Date: February 28, 2022

From: Badri Badriyha, PhD, PE
b.badriyha@outlook.com

Subject: Cottonwood Sand Mining Project Environmental Impact Report Issued 12/16/21
(PDS2018-MUP-18-023), (PDS2018-RP-18-001); LOG NO. PDS2018-ER-18-19-
007; SCH# 2019100513

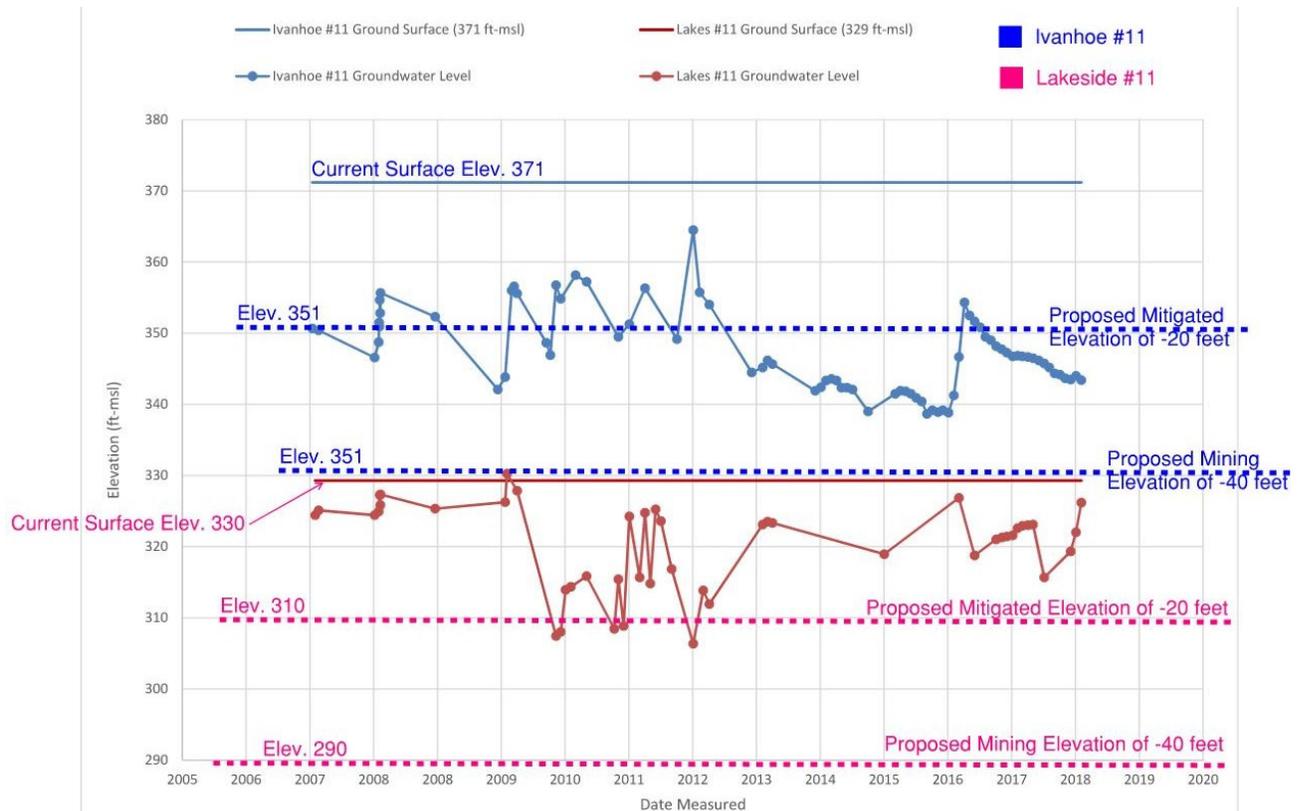
The Project will lower the ground surface by 15-20 feet. Where will be the surface of the ground water?

Ground water will follow the free surface, i.e. the excavated elevation. Consequently, the ground water level will potentially be lowered by 40 feet during the excavation phases not as claimed in Draft EIR of less than 4 feet. By removing the aquifer (the soil) which is the reservoir that hold the water, you practically removed the ground water.

Figure 9 of Appendix R - shows the ground water level at two locations Ivanhoe #11 and Lakeside #11 with no elevation reference to either the mitigated ground elevation or the lowest ground level during mining operation. Adding the proposed mitigated and mining ground elevations to Figure 9 shows the significant impact on the ground water elevations in the area, as depicted below.

The difference between the highest surface elevation of 371 and lowest excavation level of 290 is 81 feet. The impact of this proposed mining Project on lowering the ground water is significant and devastating. It will be impossible to mitigation by any mean. This severe lowering of the ground water elevation in the area will have severe and devastating impact on the hundreds of privet residential groundwater wells located immediately to the south of the project boundary as shown in Figures 5 of Appendix R-Groundwater-Investigation. All these private wells will run dry. Consequently, either abandoned or new deeper wells will need to be drilled. If these wells are abandoned, this will have significant impact on water supply as demand for potable water will increase and new resources to supply the sudden demand due to loss of the groundwater supply. If newer deeper wells are drilled, significant financial burden will be imposed on the well owners. Who will pay the construction of these new wells? Lawsuits will follow. The County will be part to these lawsuits for permitting the project knowingly it will have significant impact on the ground water. Even if the issue of who will pay for the new deeper wells is settled, the impact of utilizing deeper wells need to be addressed in the Draft EIR for the following:
